August 1, 2011
NRC3-11-0029

Subject: Detroit Edison Company Supplemental Responses to NRC Request for Additional Information Letter Nos. 18, 42, and 57

- Attachments: 1) Supplemental Response to RAI Letter No. 18, RAI Question No. 12.02-5
2) Supplemental Response to RAI Letter No. 42, RAI Question No. 12.03-12.04-6
3) Supplemental Response to RAI Letter No. 57, RAI Question No. 11.04-4

Figure 11.4-1R Solid Waste Management System Process Diagram

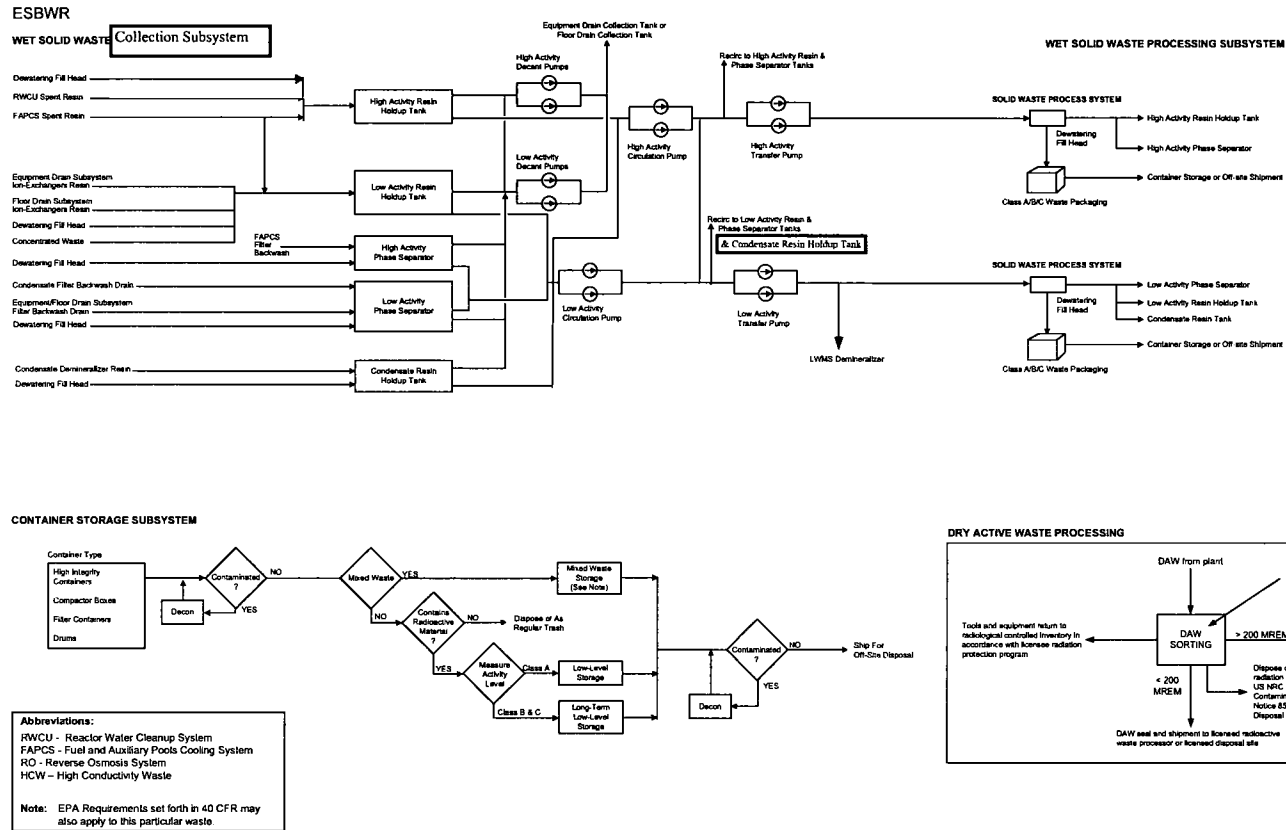
The proposed redesigned solid waste management system included the revised system process diagram in Figure 11.4-1R. However, the process diagram shows pumps in series in two places, with no holding tank or other equipment separating the pumps. This is shown for the:

- 1) Reactor Water Cleanup System (RWCU)/Fuel and Auxiliary Pools Cooling System (FAPCS) – the top process line, showing the high activity circulation and high activity transfer pumps, and
- 2) Condensate Filter Backwash Drain/Equipment-Floor Drain Subsystem Filter Backwash Drain/Dewatering Fill Head – the lower process line, showing the low activity circulation and low activity transfer pumps. These pumps are shown as tandem units in parallel but the figure does not show if these pumps provide redundancy since they are lacking isolation valves.

Additionally, the figure appears to be incomplete, in that the detail of the diagram is not sufficient for the NRC staff to fully evaluate whether the system processes are consistent with the regulatory position in Regulatory Guide 1.143 and Branch Technical Position 11-3.

It is not clear from this figure how these pumps are meant to operate, since dual pump units in series may be prone to cavitation. Please provide additional clarifications on the system operation and on the use of these pumps.

Detroit Edison provided a response to NRC RAI 11.04-4 (eRAI Tracking No. 5633) within Detroit Edison letter NRC3-11-0018, dated June 17, 2011 (ML11171A297), which included discussion of the Fermi 3 solid waste management system process flows. As discussed in a conference call with the NRC staff on July 14, 2011, further information to support this discussion is provided here as a supplement to that response, specifically Figure 11.4-1R is to be revised to depict the process descriptions in the FSAR text and in Figure 11.4-2R more comprehensively.

The block diagram represented in Figure 11.4-1R, consistent with the ESBWR DCD, represents a level of system detail to illustrate typical process flows of the Solid Waste Management System (SWMS) and is not intended to illustrate complete SWMS system capabilities. Configuration capabilities for the SWMS are shown in Figure 11.4-2R. Fermi 3 FSAR Figures 11.4-1R and 11.4-2R are currently consistent as Figure 11.4-2R shows that the system can be configured to support the flow paths depicted by Figure 11.4-1R.

As requested, FSAR Figure 11.4-1R will be revised to provide more system detail in the block diagram representation of SWMS, consistent with FSAR system descriptions and Figure 11.4-2R, as shown on the attached markups. In addition FSAR Figure 11.4-2R will be revised as shown on the attached markups.

The attached markups represent an update to FSAR Figure 11.4-1R to provide further SWMS system detail, as well as an update to FSAR Figure 11.4-2R.
